Access Compliance Report

Public Rights-of-Way

Intersection ID: 10019500	Main Street: ALICE_MCGINN_DR	Cross Street: N/A	Location: NE
ADA ID: 8B20524C4F25	Ramp Type: Perp	Initial Pass/Fail: Fail	Overall Compliance: No
Severity Score: 13.75			
Codes/Mitigation Info/Possible Solution		Field Measurements/Component Compliance

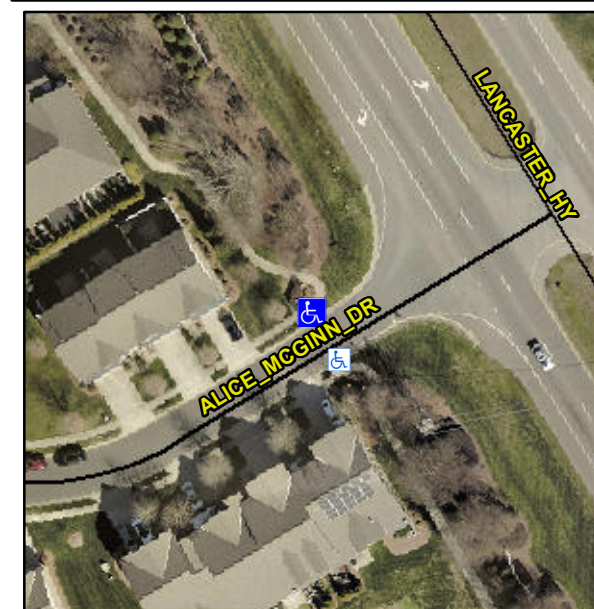
Not Found, R304.2.2, R304.5.3

Compliance	Description	Data	Compliance	Description	Data
N/A	Ramp Length (in)	49.0	No	Ramp Slope (%)	10.4
Yes	Ramp Width (in)	48.0	No	Ramp XSlope (%)	3.4
N/A	Flare Type LT	N/A	N/A	Flare Type RT	N/A
N/A	Flare Slope LT (%)	N/A	N/A	Flare Slope RT (%)	N/A
N/A	Flare Traversable LT?	N/A	N/A	Flare Traversable RT?	N/A
N/A	Landing Length (in)	N/A	N/A	DWS Provided?	N/A
N/A	Landing Width (in)	N/A	N/A	DWS Contrast?	N/A
N/A	Landing Slope (%)	N/A	N/A	DWS Length (in)	N/A
N/A	Landing X Slope (%)	N/A	N/A	DWS Full Width?	N/A
N/A	Landing Curb? (Y/N)	N/A	N/A	DWS Offset (in)	N/A
N/A	Shared Landing?	N/A			
N/A	Gutter Ponding?	N/A	N/A	Gutter Slope (%)	N/A
N/A	Gutter Lip Ht (in)	N/A	N/A	Gutter X Slope (%)	N/A
N/A	Painted X Walk1?	No	N/A	Painted X Walk2?	N/A
	X Walk 1 Direction	To SE		X Walk 2 Direction	N/A
N/A	X Walk 1 Width (in)	N/A	N/A	X Walk 2 Width (in)	N/A
	X Walk 1 Slope (%)	5.3		X Walk 2 Slope (%)	N/A
	X Walk 1 X Slope (%)	2.7		X Walk 2 X Slope (%)	N/A

Remove & Replace Entire Ramp.
